Review of egusphere-2026-2836

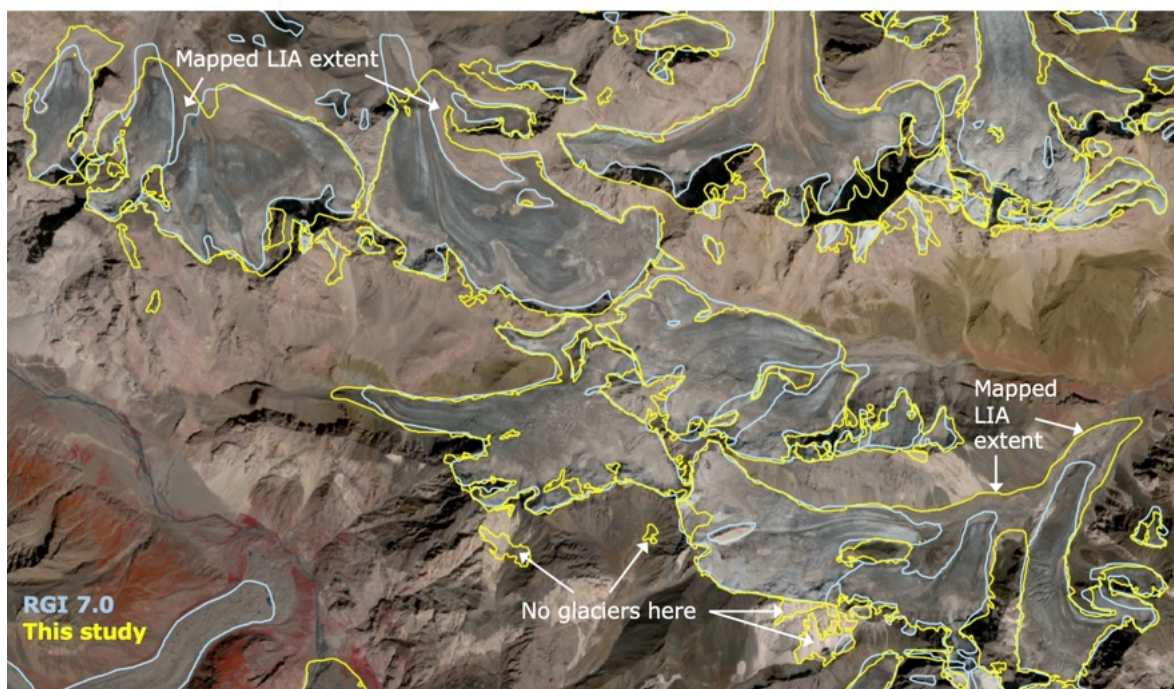
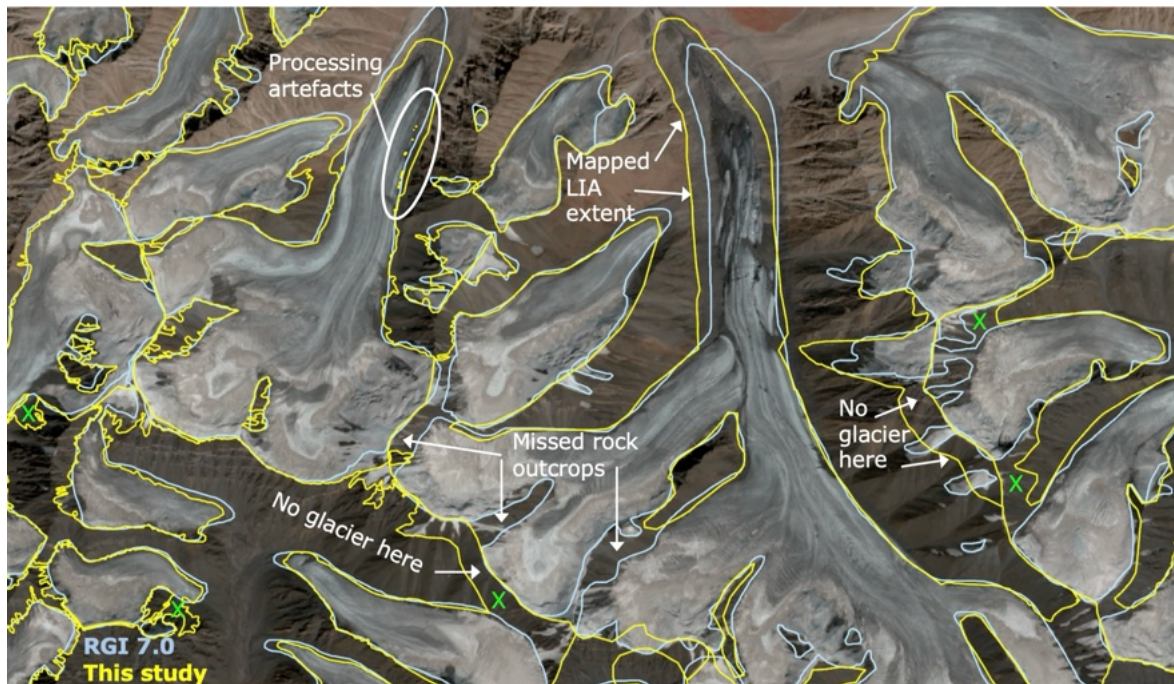
Examples 1 (top) and 2 (bottom) showing various issues with the 2mKGI inventory (yellow).
